December 5, 2019

Re: Glacier Park Neighborhood (GPN-12), Section 12, Phase 1
Final Plat Review

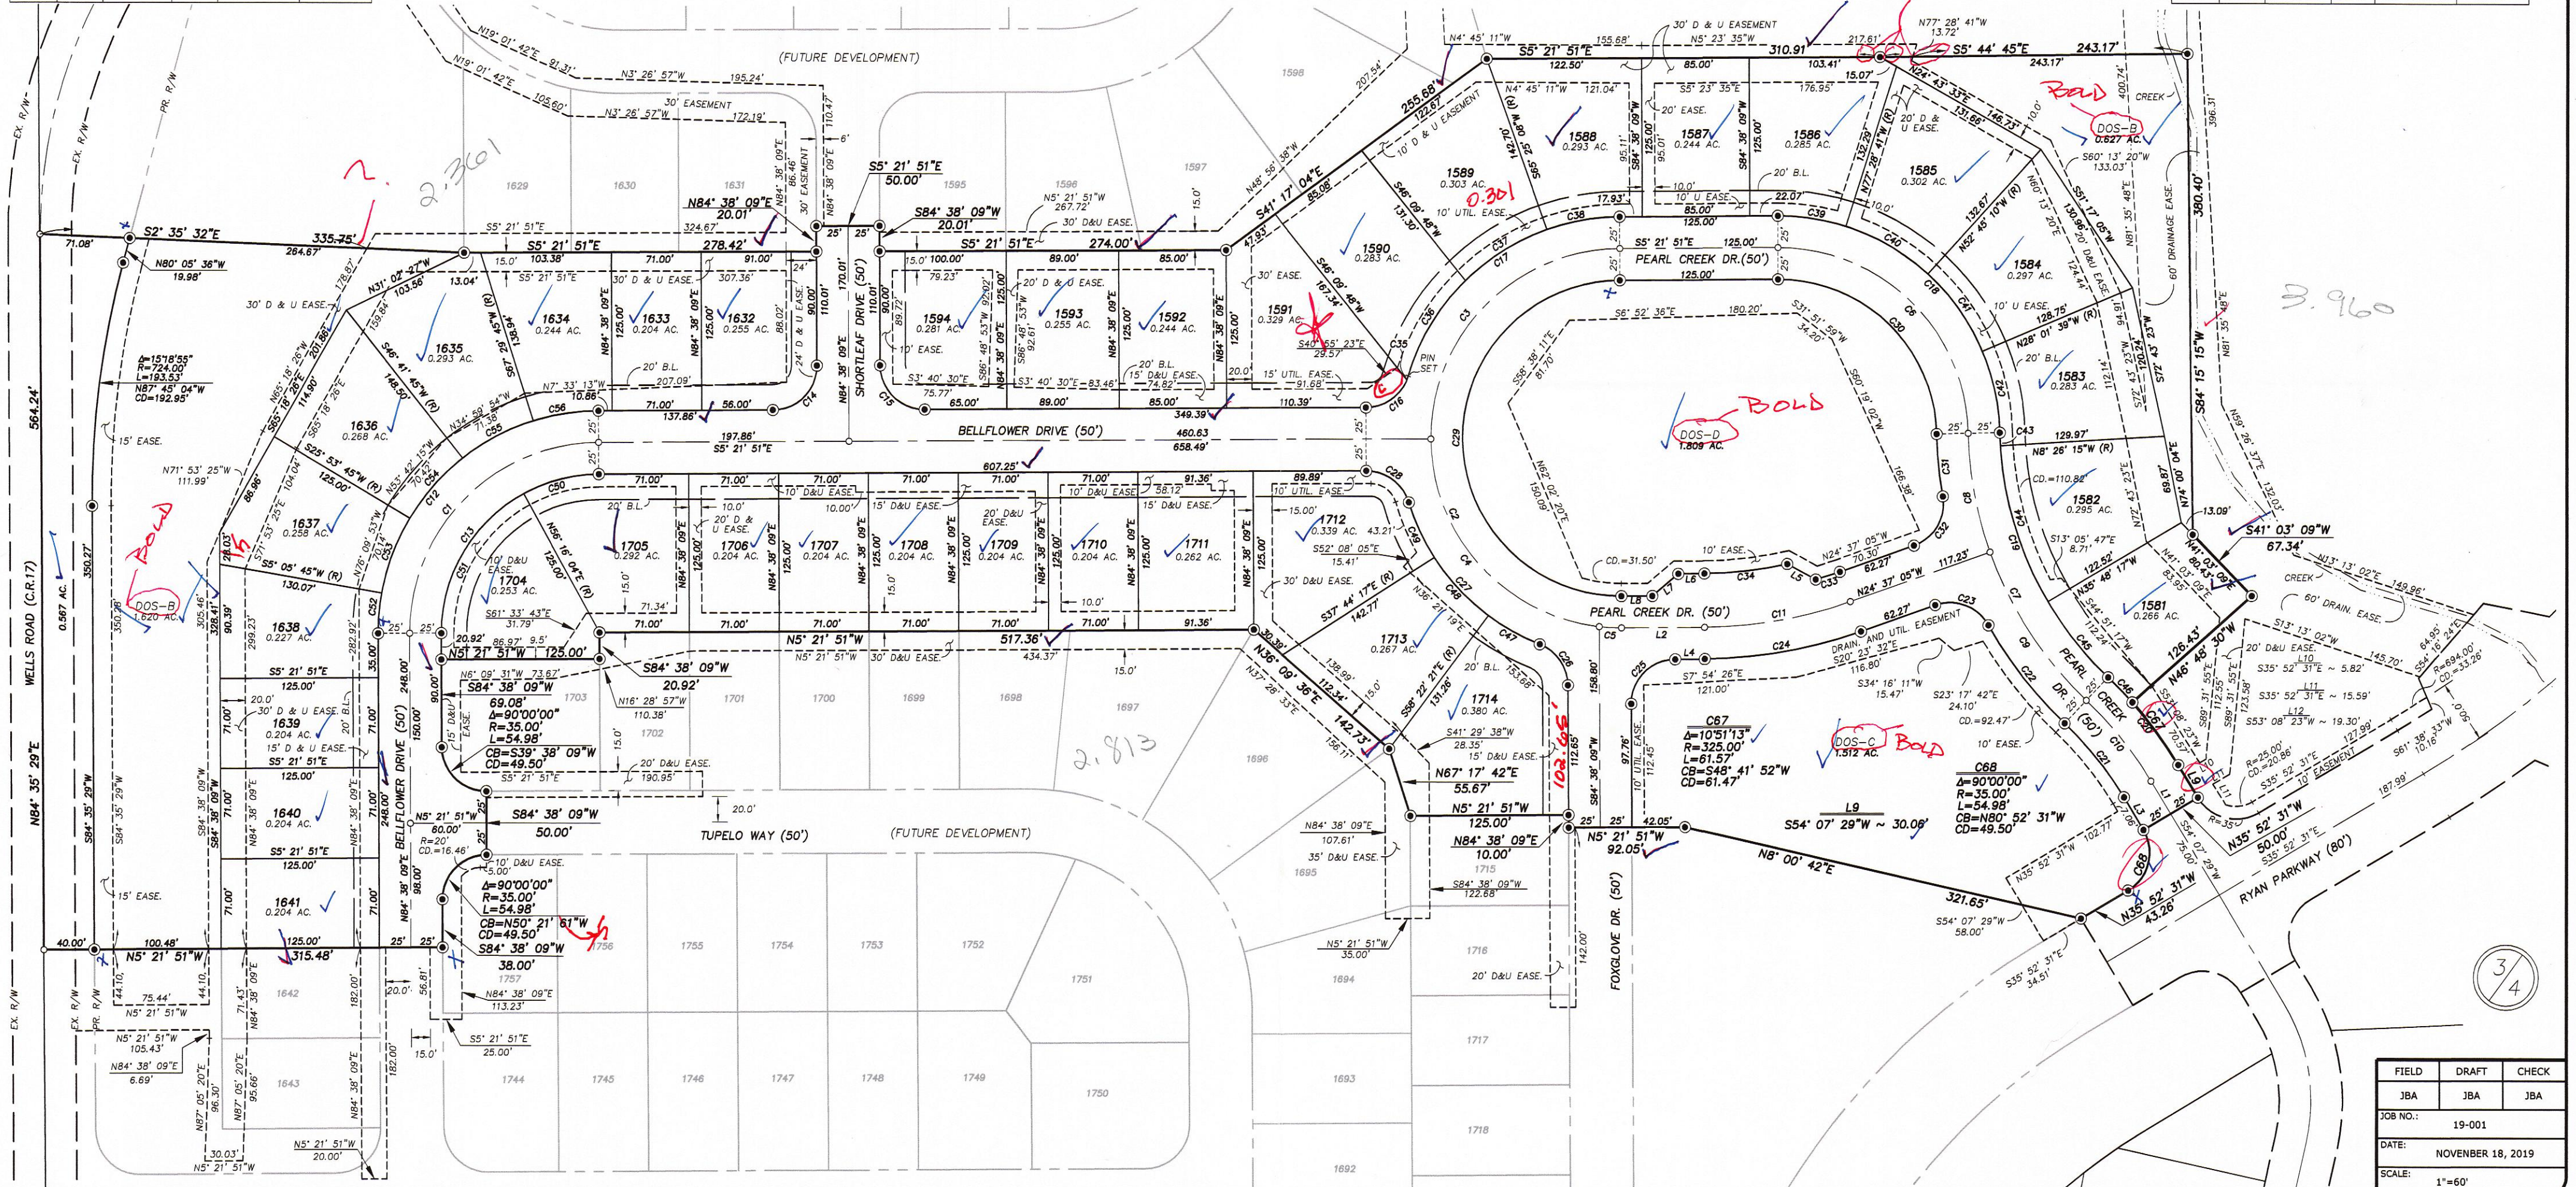
3. The 60' drainage easement south and adjacent to lot 1581 does not encompass the entire stream corridor. In addition, the stream as delineated on the plat does not appear to match the construction drawings. Please clarify. The width of the easement should, at a minimum, extend to 25' beyond the top of bank of the stream.

4. The 20' drainage and utility easement to the south of lots 1581-1585 was not shown on the engineering drawings. Consider expanding this easement into the 60' drainage easement at the rear of lots 1583 and 1584 in order to eliminate the small area in the rear of these lots where no easement exists.

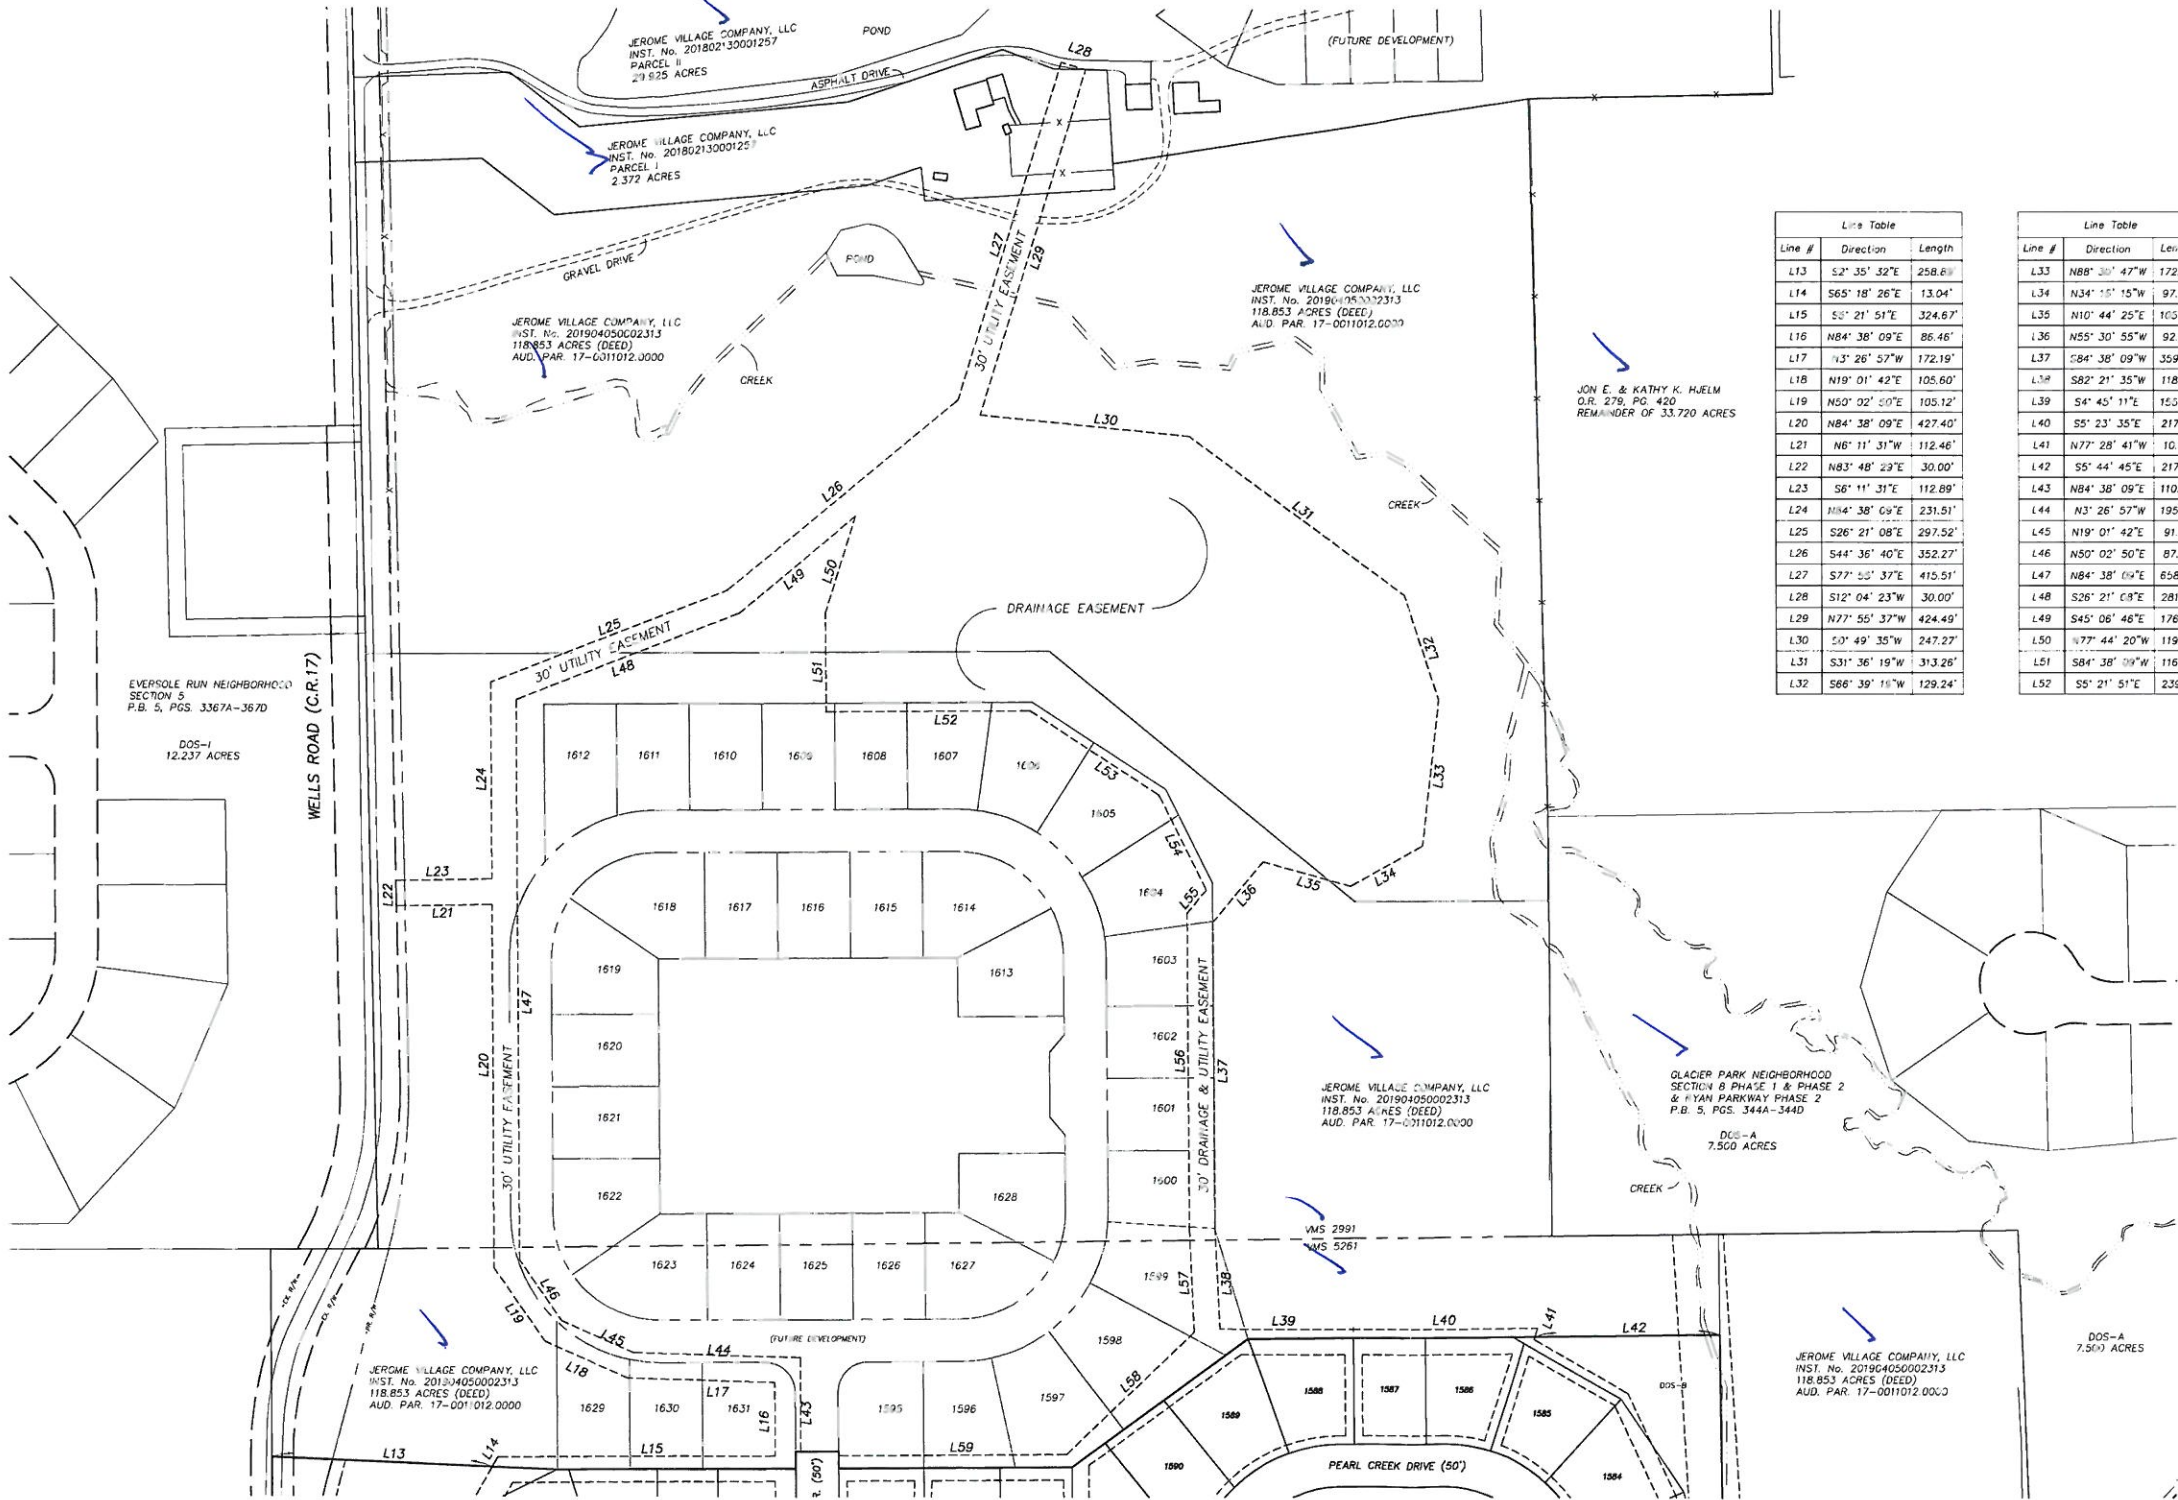
1. A clear point of beginning should be established for the metes and bounds on the easements that extend outside of the boundaries of the plat, in order to properly site them in the future.

2. Due to the offsite easements, please add a note clarifying the dedication of said easements. An example could be the following:
"Easement shown hereon outside of the platted area are within that tract of land owned by (owner, deed reference) and are hereby reserved for the uses and purposes herein."
